SUNDRY NOTICES AND REPORTS ON WELLS
Do not use this form for proposals to drill or abandon a well. Use form 3160-3 (APD) for such proposals.

8. Well Name and No.
CALOR SECO 6 FED COM 501H

EOG respectfully requests an amendment to our approved APD for this well to reflect the following changes:

Fix cement volume in bottom hole plug

Eddy County, New Mexico
Proposed Contingency Wellbore
Revised 11/11/2019
API: 30-015-46324

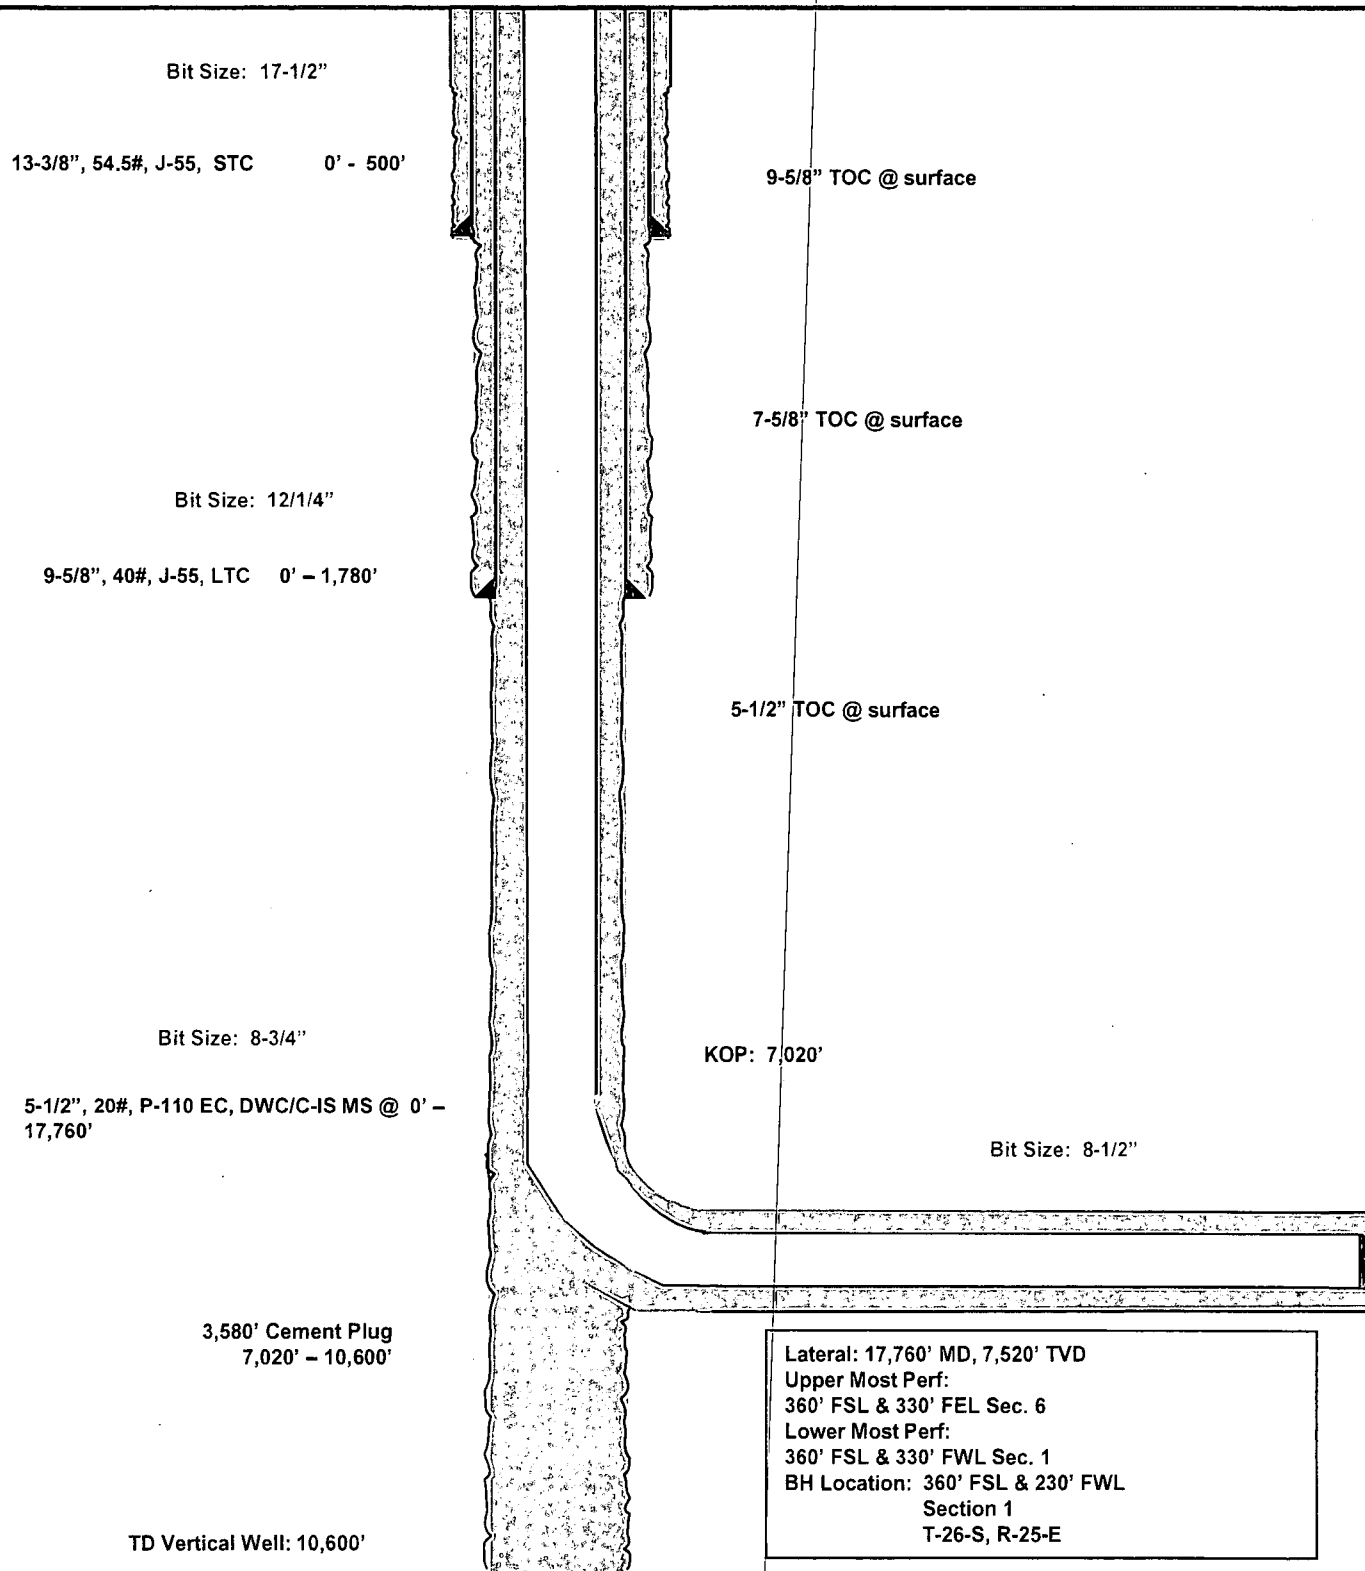
In the contingency plan, the first three casing strings will be cemented to surface per BLM request. As a part of this plan, EOG will pump a two stage cement job on the 7-5/8" intermediate casing string with the first stage being pumped conventionally with the calculated top of cement at the Brushy Canyon and the second stage performed as a bradenhead squeeze with planned cement from the Brushy Canyon to surface. If necessary, a top out consisting of 1,000 sacks of Class C cement + 3% Salt + 1% PreMag-M + 6% Bentonite Gel (2.30 yld, 12.91 ppg) will be executed as a contingency. The final cement top will be verified by Echo-meter. The 5-1/2" production string will be cemented to 500' above the milled hole in the 7-5/8" intermediate casing.
